PLANNING REPORT

Planning and Zoning Commission

All In Dublin 25-069 PDP

Address	PID: 273-013221
Location	East side of Dublin Center Drive between W. Dublin Granville Road and Banker Drive
Proposal	Construction of a four-story, 75-unit multi-family building and associated site improvements on a ±1.55-acre site
Request	Review and approval of a Preliminary Development Plan under the provisions of Zoning Code Section 153.066
Zoning	BSD-SCN, Bridge Street District – Sawmill Center Neighborhood
Planning Recommendation	<u>Approval of the Preliminary Development Plan with Conditions</u>
Next Steps	Upon review and approval of the Preliminary Development Plan, the applicant may be eligible to file a Final Development Plan application
Applicant	Mark Dunham, Executive Director, All Inclusive Living
Case Manager	Bassem Bitar, AICP, Deputy Director of Planning (614) 410-4635 bbitar@dublin.oh.us

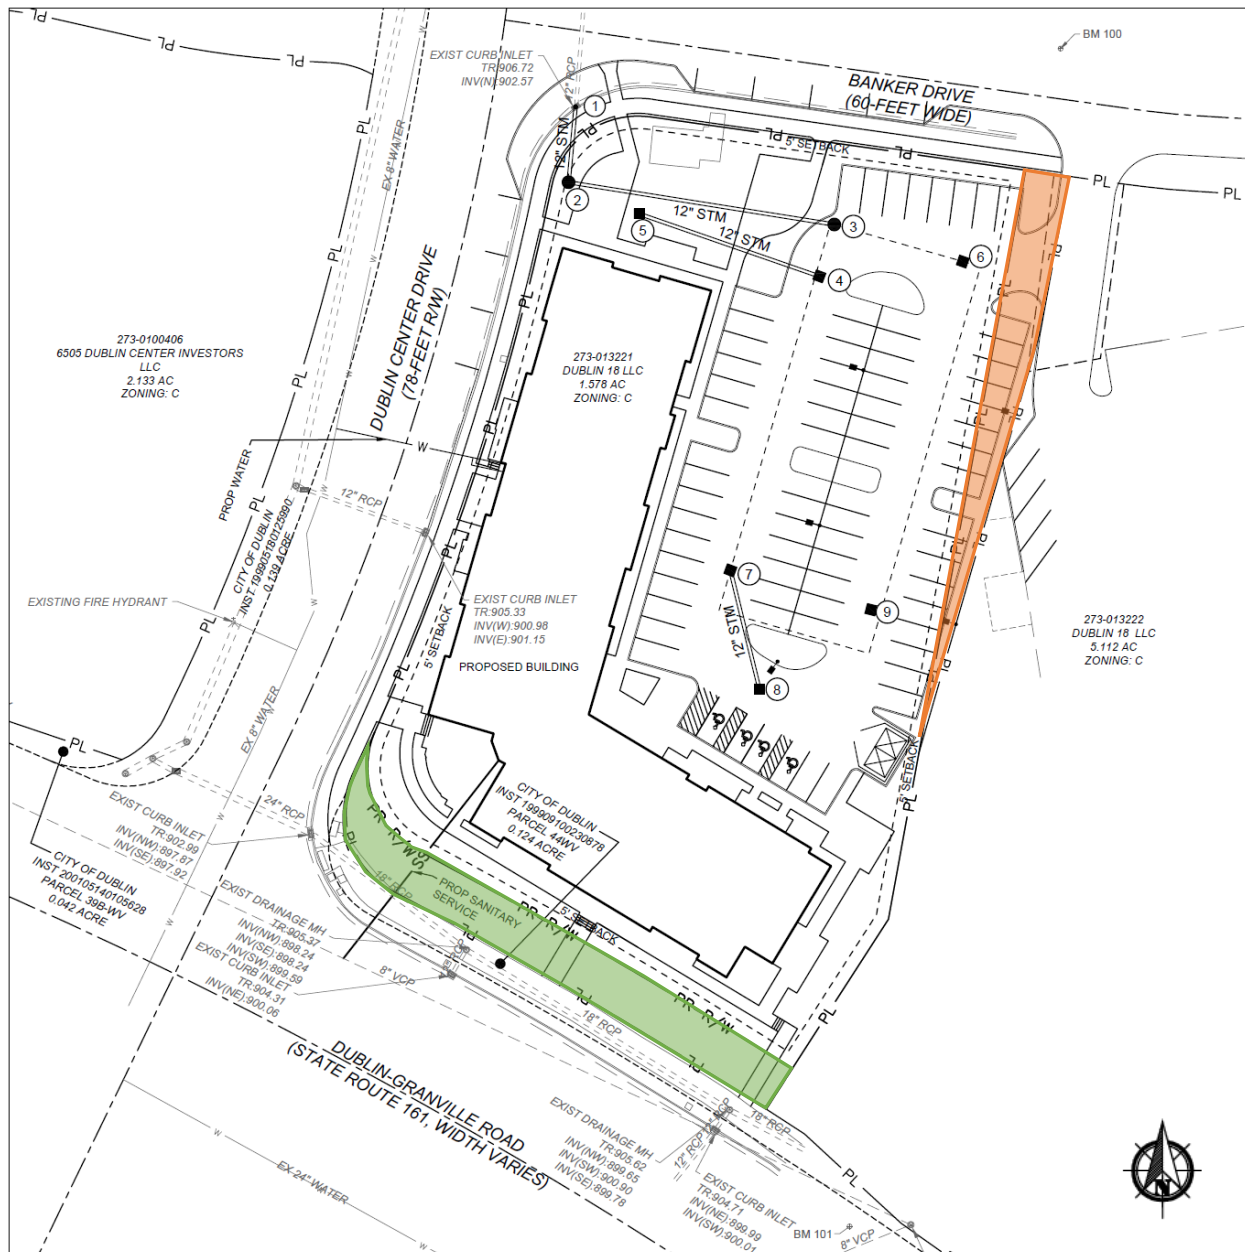
The Apartment Building Type standards stipulate a 5-20 foot RBZ along both the front and corner side property lines. While the RBZ is shown on the architectural sheets, it is not reflected in the site plan (which only shows the minimum 5' sidewalk). It will need to be shown at the Final Development Plan (FDP) stage to confirm that the front property line RBZ is met. The northernmost façade of the building is approximately 62' on average from the Banker Drive property line, so a Waiver from the corner side RBZ is required and addressed below.

The Apartment Building Type standards require a minimum front property line coverage of 75%. Pending confirmation of the front facades being entirely within the RBZ, it appears that the coverage is slightly less than 75% along both frontages, but likely within the Administrative Departure range. This will be addressed at FDP.

The original parcel is 1.578 acres in area. With the addition of 0.059 acres to the east (shown in orange on the site plan above) and the dedication of approximately 0.090 acres of public right-of-way to the south (shown in green), the net acreage is approximately 1.55. The proposed impervious area is 1.18 acres, yielding a lot coverage figure of approximately 77%, which exceeds the 70% limit. A Waiver may be warranted given the amount of right-of-way dedication, although further study of the balance between open space and parking should take place at FDP.

The parking lot is proposed at the rear of the building as required, but it is not clear if it meets the minimum 5' side yard setback (the setback line is shown relative to the existing rather than the new east property line). The dumpster enclosure and pad appear to encroach into the setback. Clarification will be needed at FDP.

The applicant is proposing to utilize an underground detention structure for stormwater management. As currently shown, this structure would extend below a couple of landscape islands thus impacting the ability to plant the trees shown in the landscape plan. The applicant

1. The applicant update the Site Plan to reflect the Required Building Zone and side yard setback and confirm compliance with the applicable standards at the Final Development Plan stage (FDP).

2. The applicant continue to work with staff on addressing the lot coverage and open space standards at FDP.
3. The applicant work with Engineering staff to complete stormwater management calculations that are compliant with the City's stormwater regulations and provide the correct critical storm calculations prior to submittal for FDP.

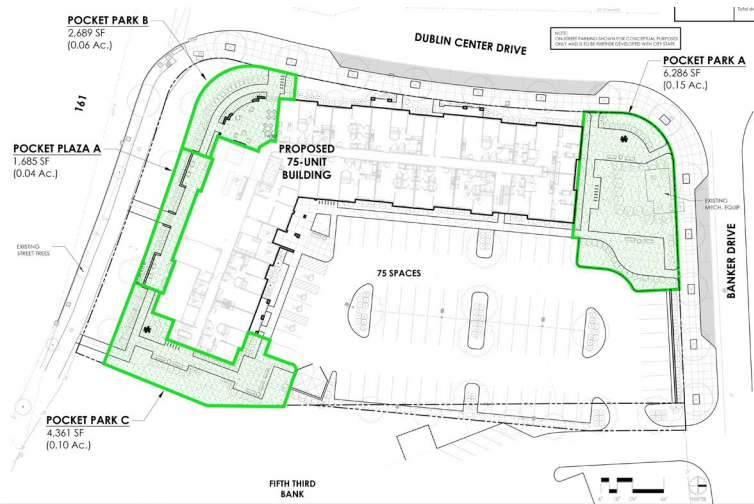
As noted above, streetscape improvements are proposed along Dublin Center Drive and Banker Drive, including the addition of on-street parking per the BSD standards. The exact number of parking spaces and details of the restriping that will be needed along those streets will be determined through continued coordination with the Transportation & Mobility and Engineering staff. Additional details, including verification that the sidewalk widths and grading will meet the standards will be provided at FDP.

5. The applicant continue to work with staff on incorporating the BSD Streetscape Character Guidelines including incorporation of on-street parking.
6. The applicant continue to work with staff on finalizing the on-site parking details.
